FCO 04488 – Hood upgrade

Applies to ☑ Magnus VLF Autoloader

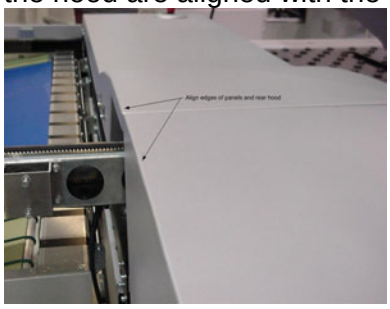
Background This upgrade eliminates side-to-side play in the rear hood.

1. Install part number 252-06730 on the underside of the rear hood straddling the hood rib and hinge bolt. Use the existing fastener and washer.

2. Before tightening the hood lock in place, make sure the ends of the hood are aligned with the sides of the machine.

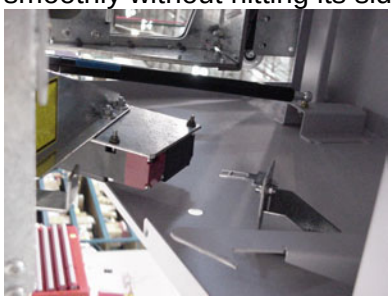
3. Once the hood is aligned, tighten the hood lock down.
4. Adjust the two safety switch interlocking keys (one on either side of the device) so that the key penetrates the lock opening smoothly without hitting its sides.
